Glazing Addendum 2
Bid Packages - 11.0, Interior Glazing

No 9557460
UCD Medical Campus Operating Modernization

This addendum to the RFP documents consists of pages AD-1 thru AD-12.

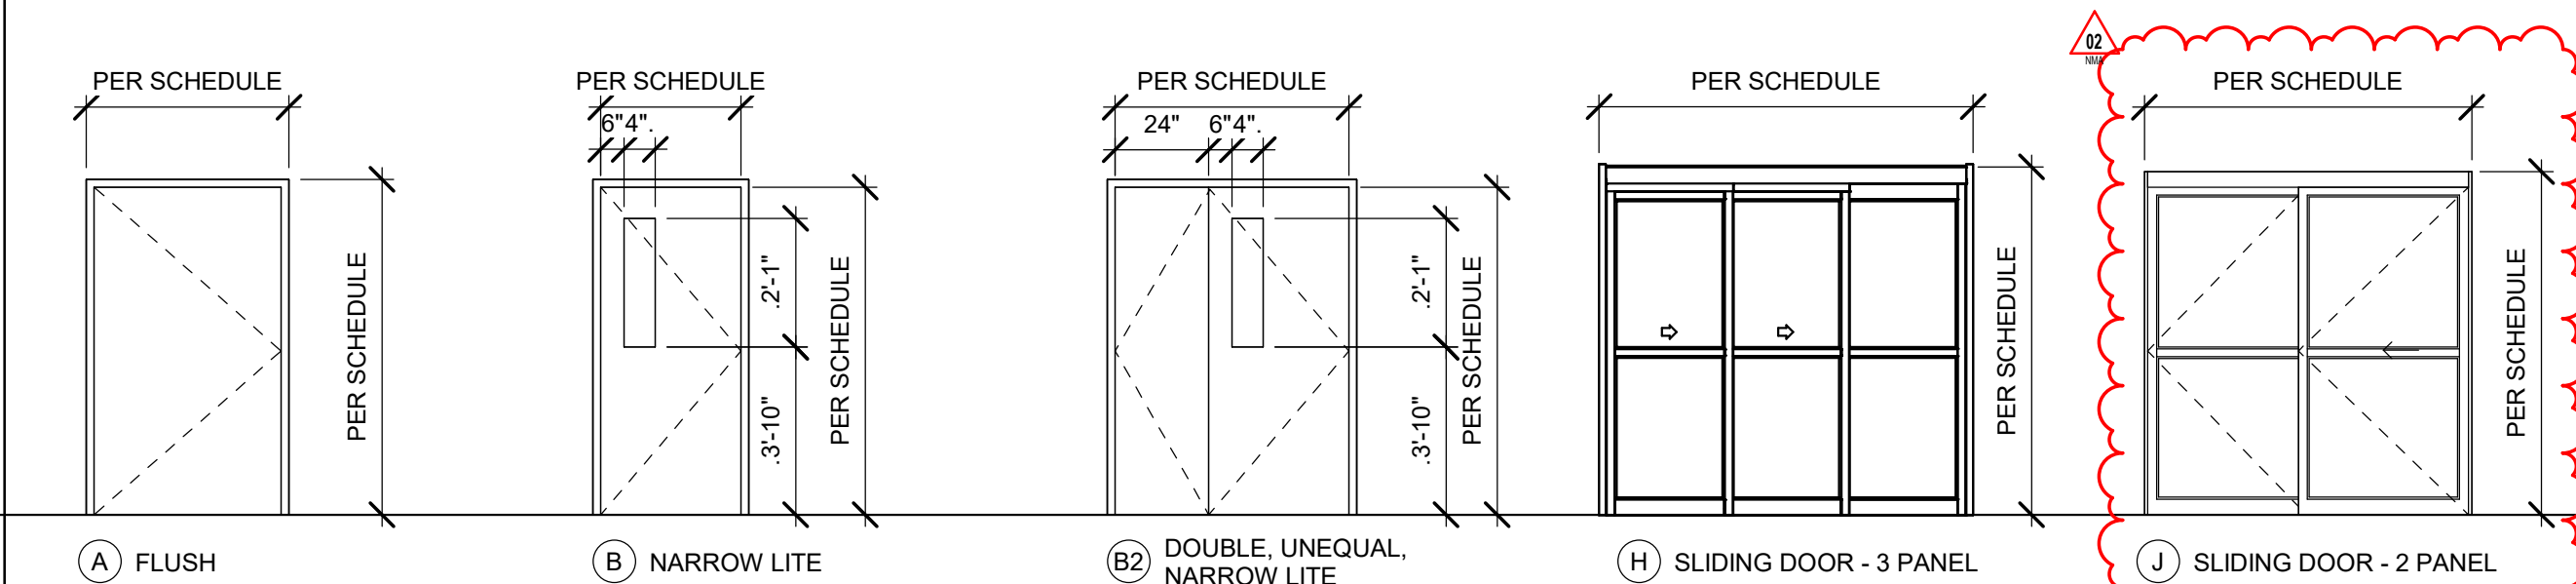
2. A revised door schedule has been included below. Attached document to be reviewed and incorporated into pricing.

PROCARE™
8300
SERIES

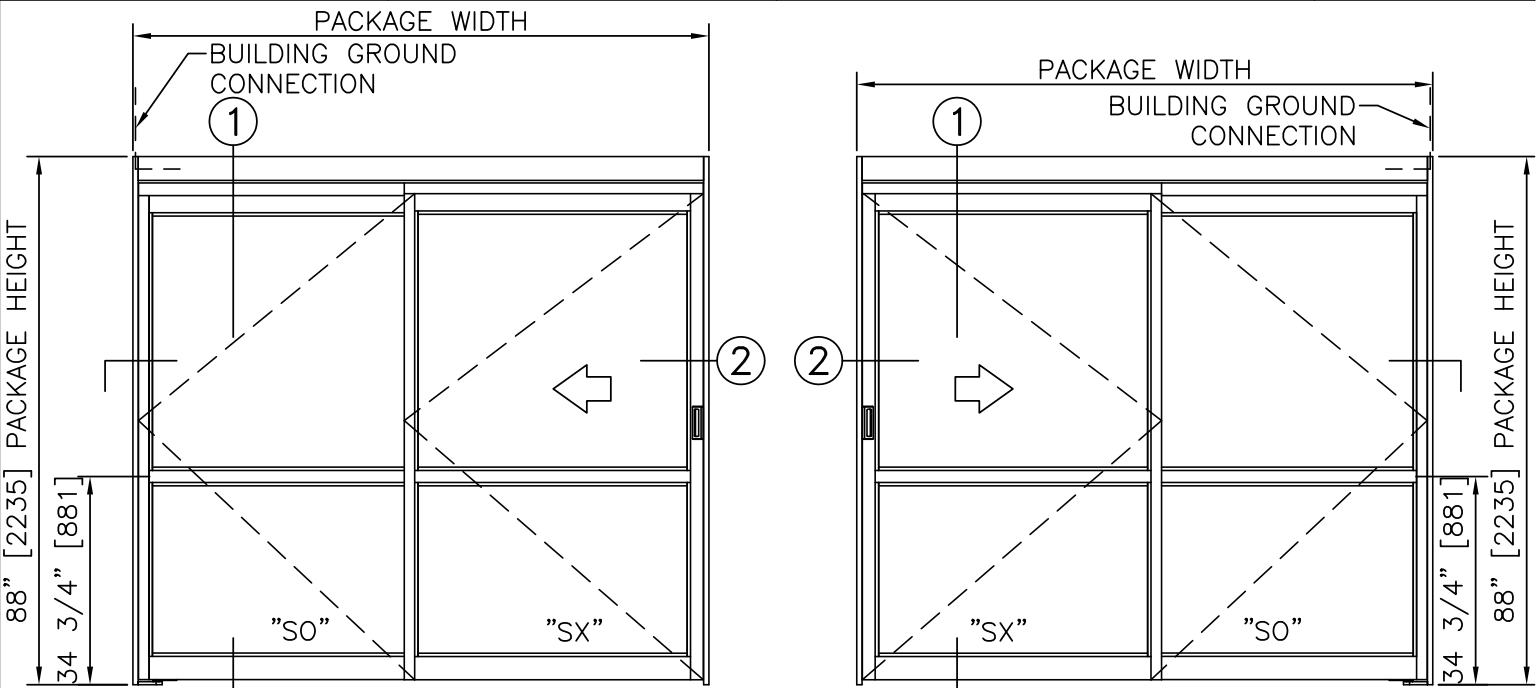
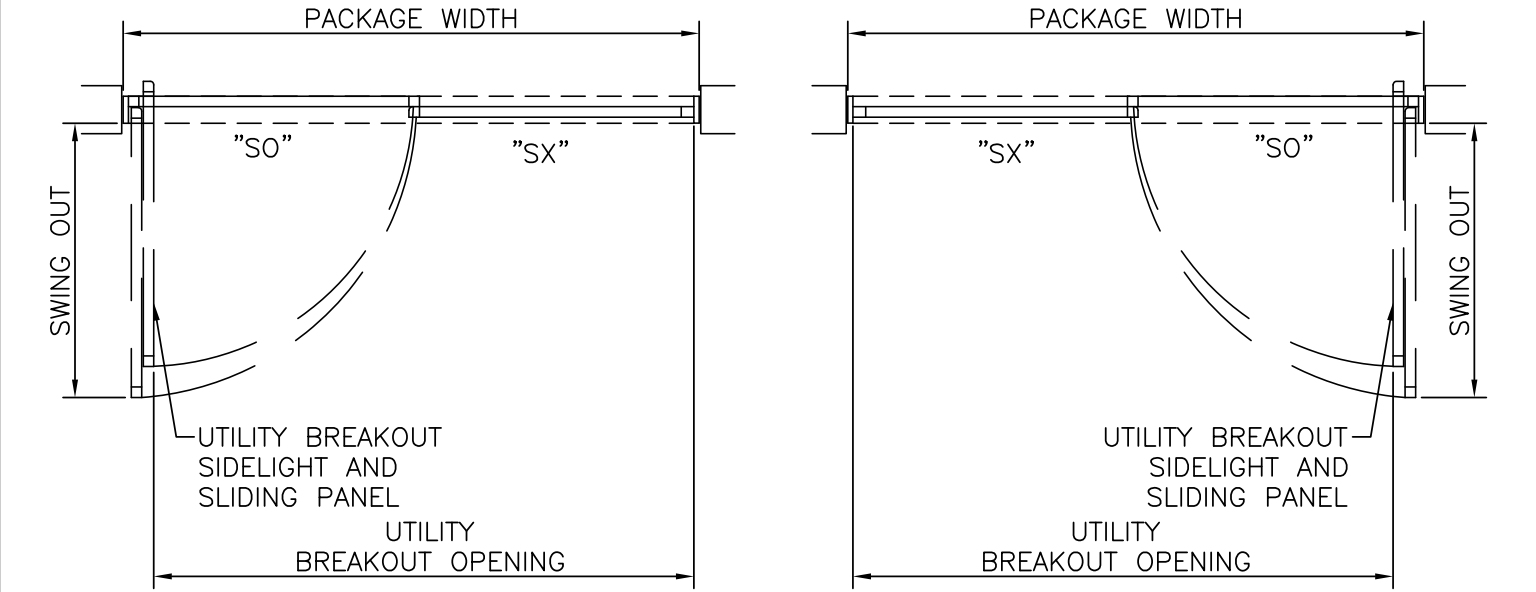
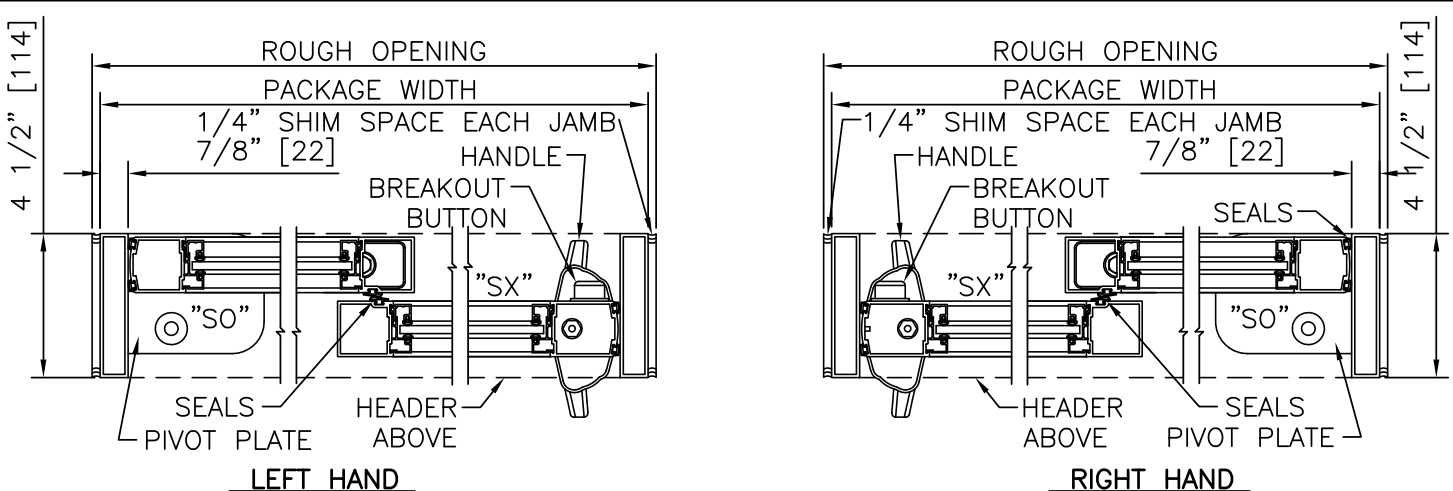
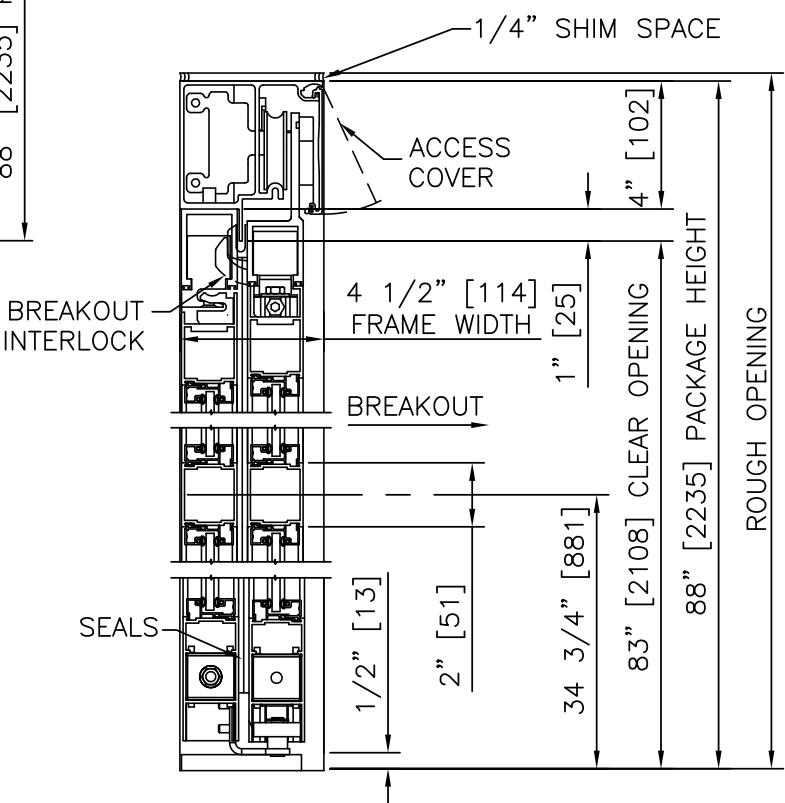
1. Stanley doors required for this project are attached below. Assume the installation of PACU doors to be Manually operated and OR specialty sliding doors to be automatically operated. We understand there is difficulty receiving information from Stanley at this time, please refer to updated scope of work included below and provide pricing in accordance to the details provided.
 - a. PACU = 8300
 - b. Pump Rooms = 8500A
